PRELIMINARY ASSESSMENT REPORT

PROJECT: *Uplands MS Project*

ADDENDUM TO PA REPORT IMO_REP_026

*Review of Revised Connection Scheme for the
Proposed Facilities*

FIGURE 1A

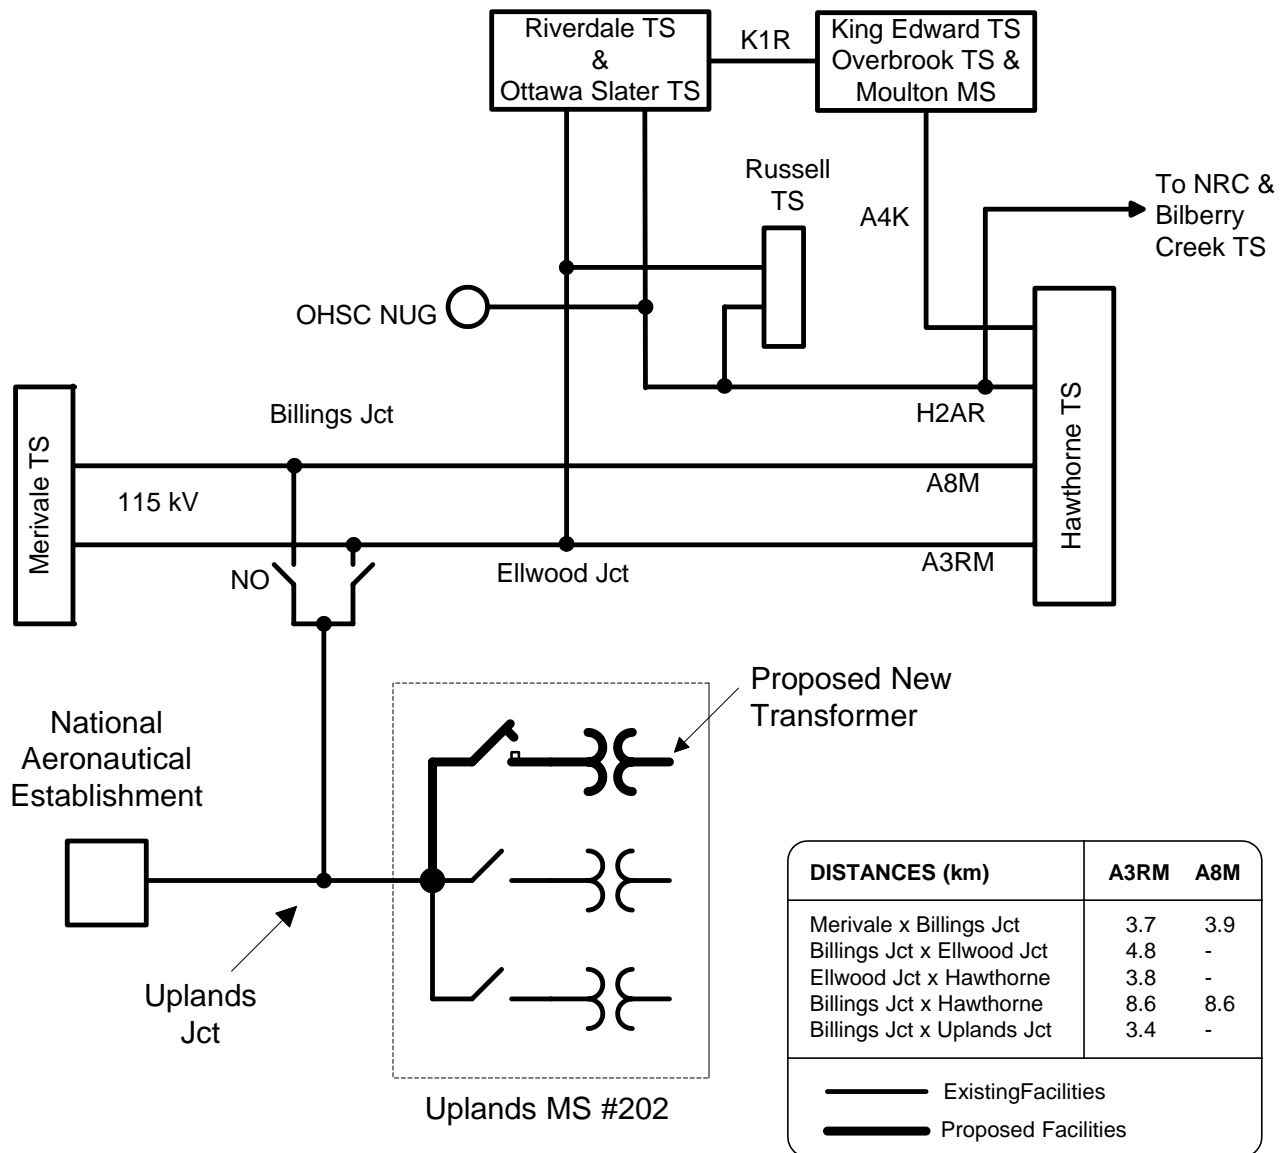
Hydro Ottawa advised that they have revised the connection arrangement for adding the proposed third 115-27.6 kV, 20/33 MVA transformer to 115 kV circuit A3RM at their Uplands MS. Previously, the proposal was to add an additional dead end structure and extend the 115 kV overhead strain bus to an adjacent property where the new transformer and associated facilities were to be located.

Hydro Ottawa have encountered problems in acquiring the adjacent property needed for the original proposal and have decided instead to build the proposed facilities within the present Uplands MS station site. This requires a modification to the 115 kV connection in that the existing strain bus will not be extended to incorporate the proposed new facilities. Instead they are proposing to connect to the existing 115 kV dead end structure and drop down onto an open bus, to which the new facilities will be connected.

The Proposed revised connection is shown schematically in Figure 1A.

A review of this project with the changes described above, indicates that the proposed facilities will not have any adverse impacts on the IMO-controlled Grid.

Based on the above, it is concluded that this project may proceed in its revised form described above, subject to meeting the requirements identified in Section 4.0 of the Preliminary Assessment Report IMO-REP-026, dated July 25, 2001.

FIGURE 1
HYDRO OTTAWA: UPLANDS MS PROJECT

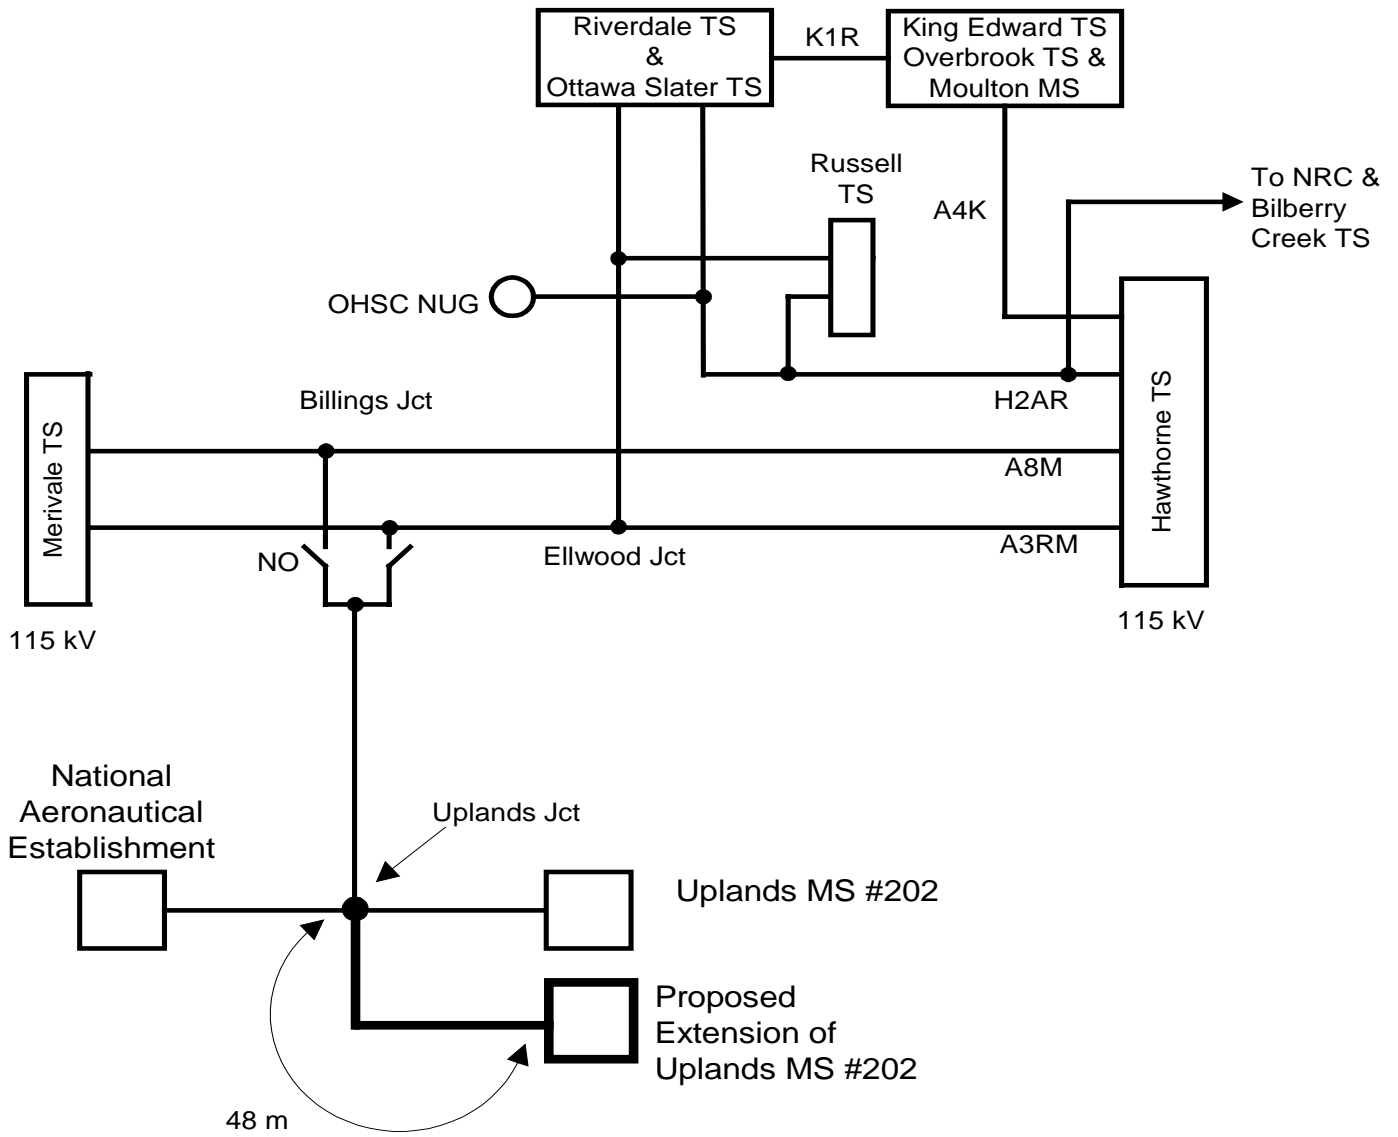
The proposed new 115-27.6 kV transformer will be supplied from an existing Hydro One 115 kV radial tap (approx 3.5 km) normally connected to the Merivale TS x HawthorneTS 115 kV circuit A3RM, but switchable to A8M, as shown in Figure 1. In addition to the proposed new transformer, the 115 kV radial tap also supplies the existing Uplands MS #202 and the National Aeronautical Establishment.

FIGURE 2

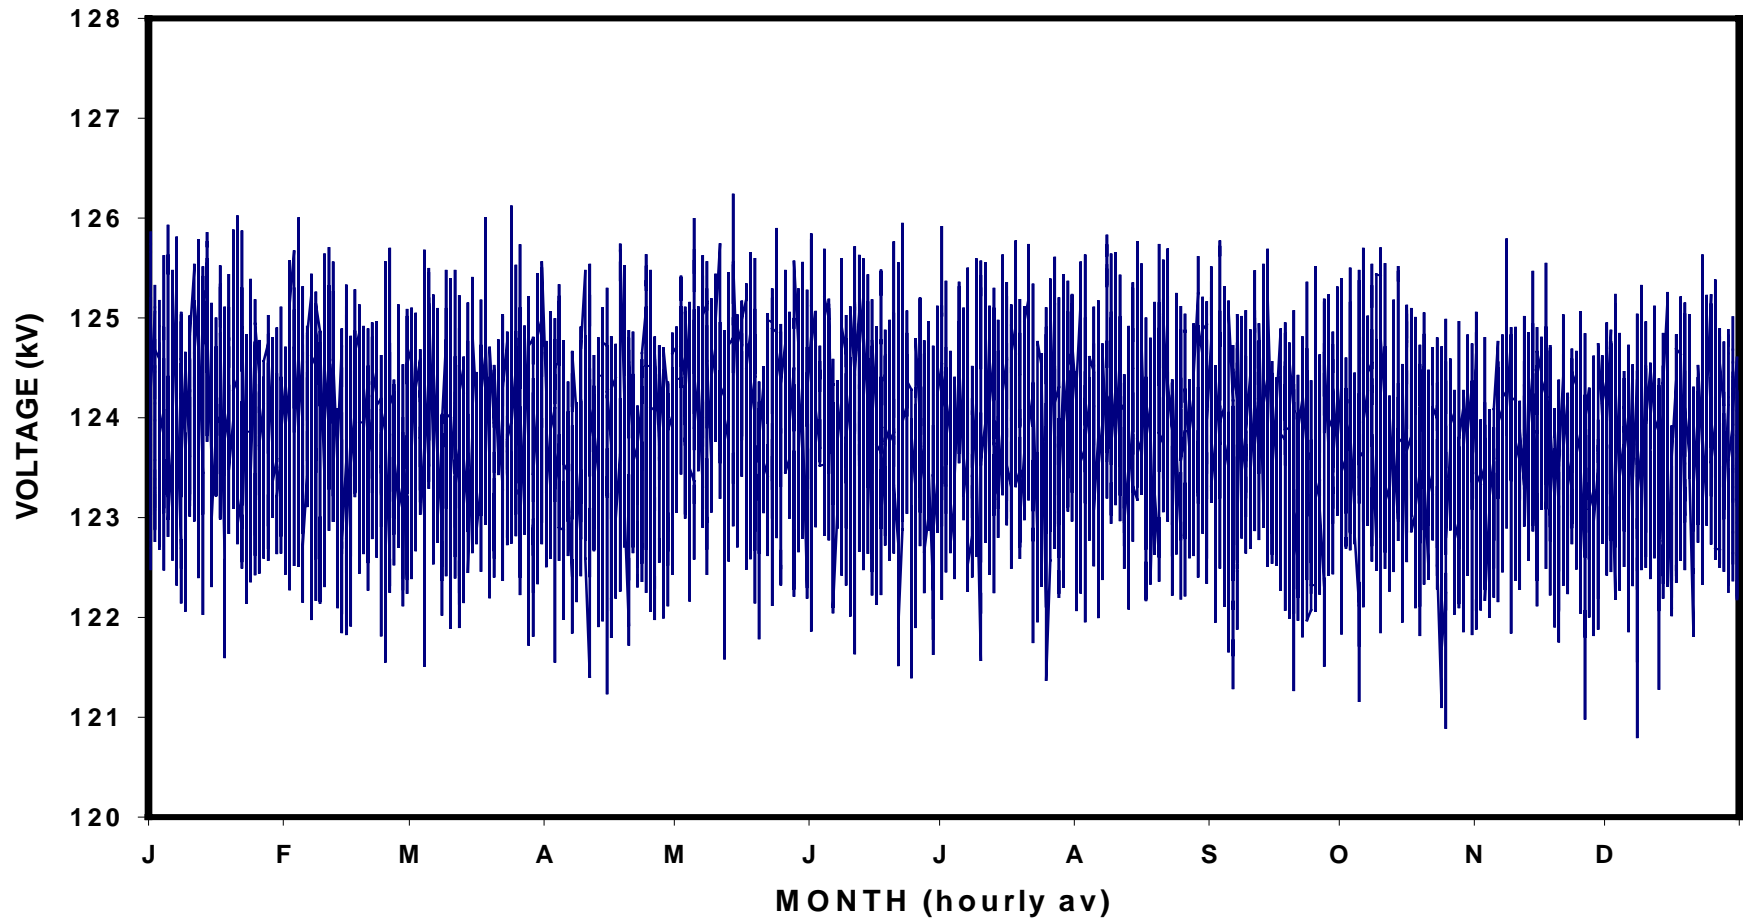
Figure 2 shows the actual measured voltage at Hawthorne TS 115 kV bus during the year 2000. The voltage at the location of the proposed new Uplands transformer is expected to be approximately 1 kV below the level at Hawthorne TS.
